Merri-bek
City Council

COUNCIL AGENDA

- 5.1 81 DAVIES STREET, BRUNSWICK - PLANNING APPLICATION
- MPS/2026/101

Property:	81 Davies Street, Brunswick
Proposal:	Construction of four triple storey dwellings
Zoning and Overlay/s:	- General Residential Zone – Schedule 1 - Development Contributions Plan Overlay
Strategic setting:	Minimal change Incremental change Significant change
Objections:	12 Objections - Key issues raised: - Neighbourhood character - Overdevelopment - Traffic
Planning Information and Discussion (PID) Meeting:	- Date held: 30 June 2026 - Attendees: 6 objectors, the applicant, 2 Council officers, and Cr Irvin - Prior to this meeting, the applicant submitted discussion plans showing compliance with the front street setback standard of Clause 55. Following this meeting, the applicant agreed to conditions requiring an improved stormwater management response, overlooking treatment and relocation of A/C units.
ESD:	Sustainability objectives and standards of Clause 55 are met, noting Council's Environmentally Sustainable Design Policy is no longer a relevant consideration for this application.

PLANNING ENVIRONMENT ACT 1987
MERRI-BEK PLANNING SCHEME
Advertised Document
Advertised Plan Sheet 4 of 14
Application No: MPS/2026/101
Date: 19/05/2026

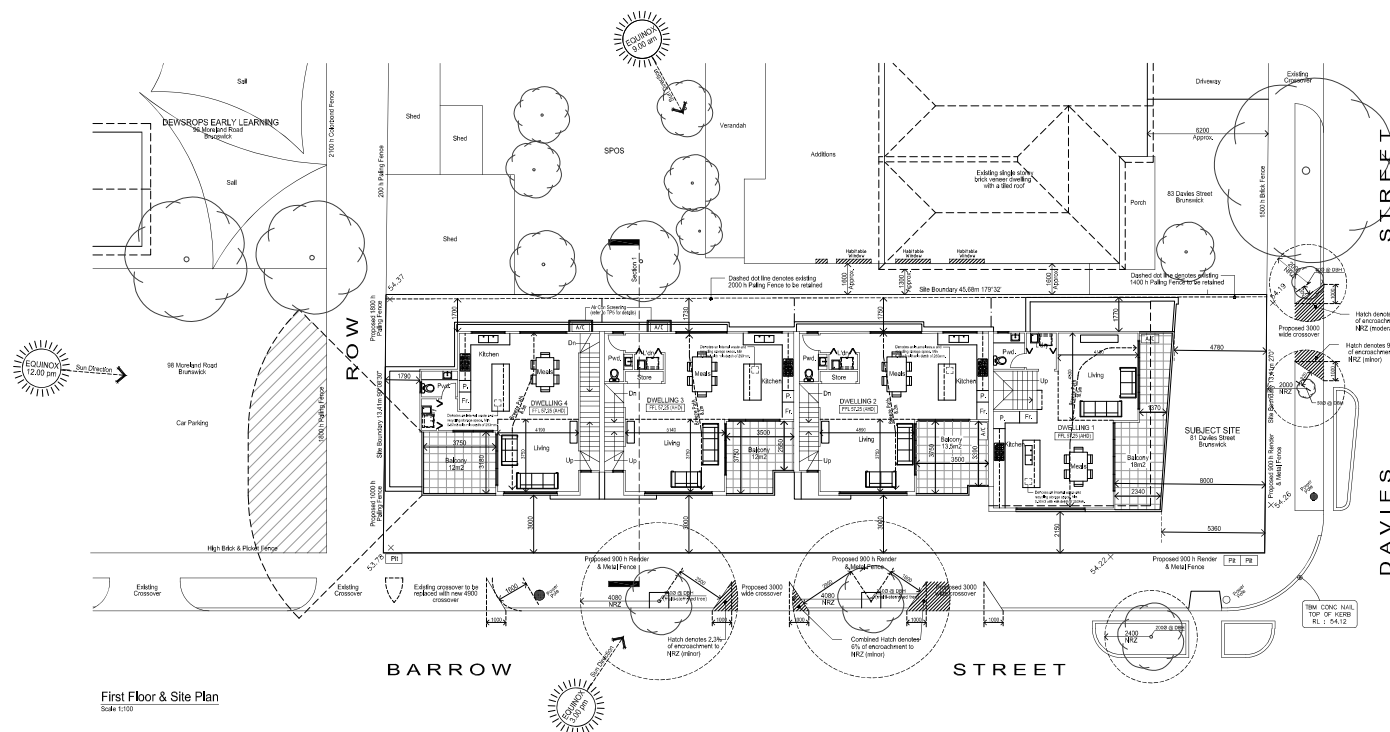
- a) Changes, generally in accordance with the discussion plans dated 26/06/2026, including:
 - i. Reducing the size of the balcony to Dwelling 1 and ensuring the first floor does not encroach into the 6 metre front setback.

- c) The east facing second floor bed 4 windows of Dwelling 2 and 3 to have fixed obscure glazing to a minimum of 1.7 metres above finished floor level.

- d) The east-facing first floor powder room windows of Dwellings 1 to 3 must be obscurely glazed and restricted to a maximum opening of 10 millimeters.

- e) The east facing stairwell windows of all dwellings to have fixed obscure glazing to a minimum height of 1.7 metre above finished floor level.
 - f) Removal of the two street trees located on the nature strip along Davies Street, adjacent to the crossover serving Dwelling 1.

- g) The air conditioning unit associated with Dwelling 3 must be relocated to the second floor south-facing wall of bed 4.
 - h) The air conditioning unit associated with Dwelling 4 must be relocated to the first floor north-facing wall of the laundry.

- i) Floor plans updated to show the setbacks of the dwellings measured from the eastern title boundary.
 - j) An updated schedule of all proposed exterior decorations, materials, finishes and colours, which includes:

Discussion plans were submitted by the applicant on 26/06/26 to address this variation. The plans show the balcony for Dwelling 1 being reduced in size, so it no longer extends into the required front setback. The discussion plans also show a porch, which meets the allowable encroachment under the standard, for the future residents of Dwelling 1. A condition of the recommendation is included to reflect this change.

The advertised floor plans show setbacks measured from the existing fence line, which do not align with the title boundaries. As the planning standards require setbacks to be measured from title boundaries, a condition of the recommendation will require this detail to be included, noting that the discussion plans provided on 26/06/26 show this detail, in addition to compliance with the standard.

PLANNING ENVIRONMENT ACT 1987
MERRIBEEK PLANNING SCHEME
Advertised Document
Advertised Plan Sheet 6 of 14
Application No: MPS/2026/101
Date: 19/05/2026

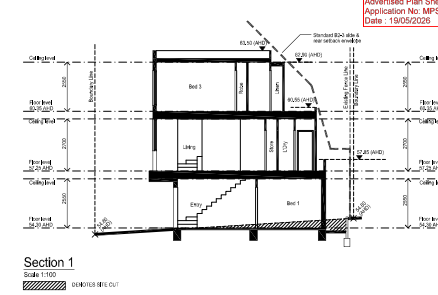
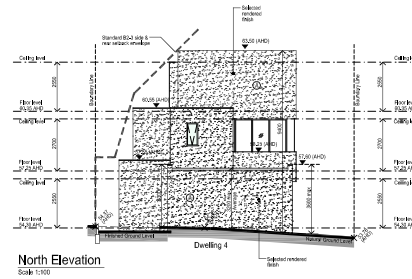
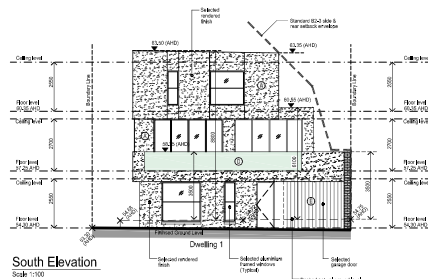
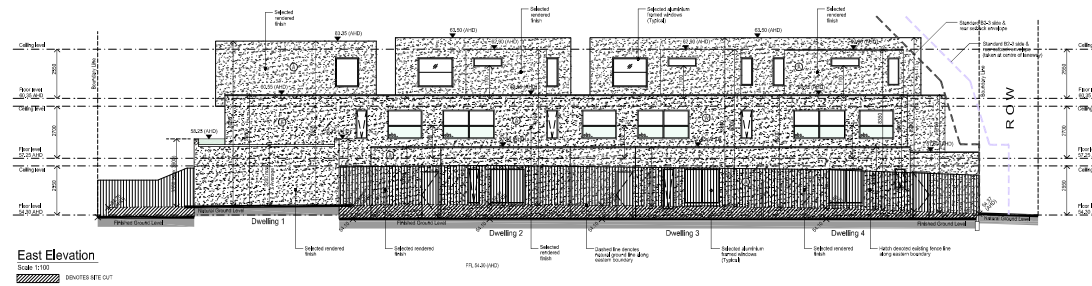
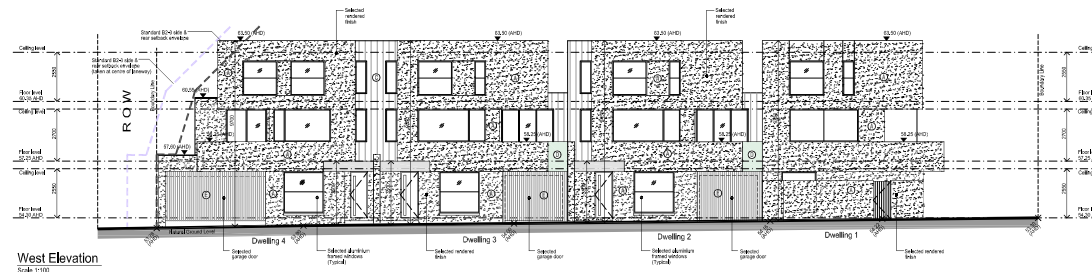
- b) The elevations updated to include a notation that confirms all windows nominated as 'obs' as fixed shut obscure glazing to a minimum of 1.7 metres above finished floor level.

- i. Weatherboard cladding or similar to be the primary and visually dominant material to the first and second floors, covering the majority of visible external wall areas.

- ii. The use of monument for any external surfaces of the building to be replaced with lighter colour tones.

Advertised Document
Advertised Plan Sheet:10 of 14
Application No: MPS/2026/101
Date : 19/05/2026

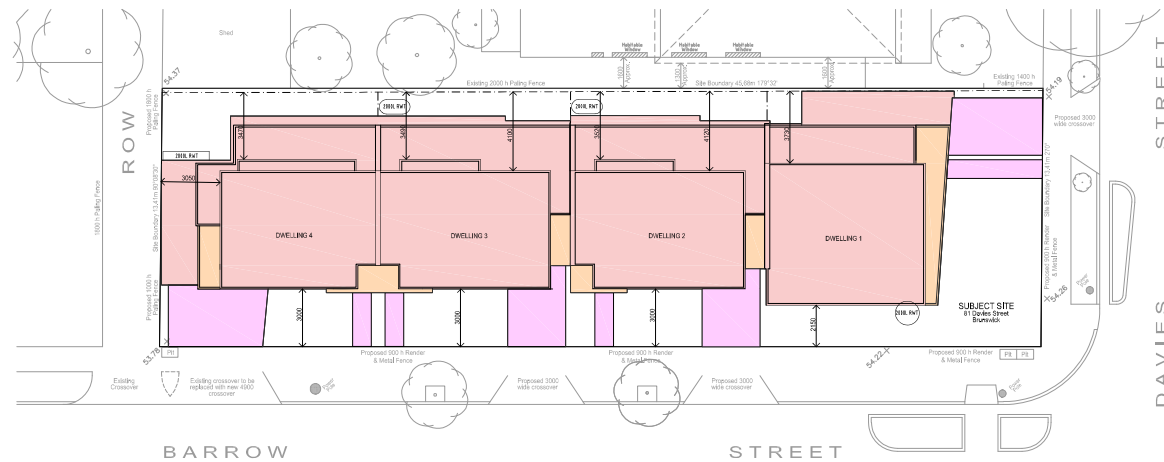
- a) Plans modified to show compliance with Standard B5-1 Clause 55.05-1 (permeability and stormwater objective) by:
 - i. Providing an amended WSUD (Water Sensitive Urban Design) catchment plan that is consistent with the Blue Factor report, clearly showing roof details including location of parapet walls, box gutters, roof fall direction, and downpipes (either charged, gravity or internal) to demonstrate how stormwater catchments drain to the rainwater tanks without charged pipes running under building slabs.

- ii. Providing a Blue Factor report and stormwater management response that:
 - Maintains a minimum score of 100 per cent but is modified so that the dwelling 1 roof area is approx. 89.4m², to match the WSUD plan.

- Achieves an 80 per cent reduction in suspended solids mean annual load

- **Adequate permeability and stormwater management.** Conditions of the recommendation seeks to improve the blue factor response by increasing the suspended solids reduction to a minimum of 80 percent.
